Product / Process Change Notice

Change presentation: Increase of inflator use by date

Part reference before the change: 19904-00271_02.0

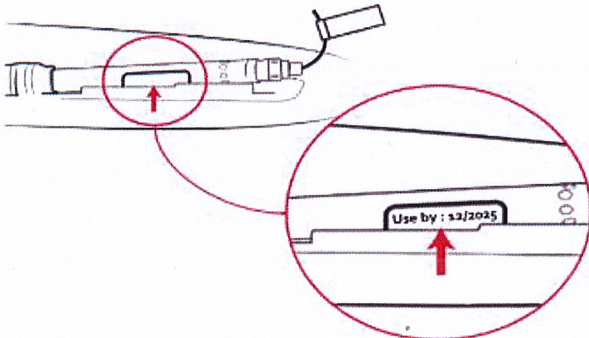
<p>The tests realised by the manufacturer, listed in our report TP1612-009, and according to the analysis of anonymised riding data, the inflator use-by date is extended by 6 years.</p> <p>Rules for use-by determination:</p> <ul style="list-style-type: none">- Use-by date on inflator label is 2027 or earlier: inflator lifetime is extended by 6 years- Use-by date on inflator label is 2033 or later: inflator lifetime remains as is.	 <p>The image shows a technical drawing of an inflator. A red circle highlights a specific part of the inflator, and a red arrow points to a callout. The callout shows a label with the text 'Use by : 12/2025' and a red arrow pointing to the date.</p>
--	---

Impact description: inflators in possession of users can be used 6 more years if produced until 2022 and don't need to be replaced. Inflators produced from 2023 will have a 10-year use-by date printed on the label.
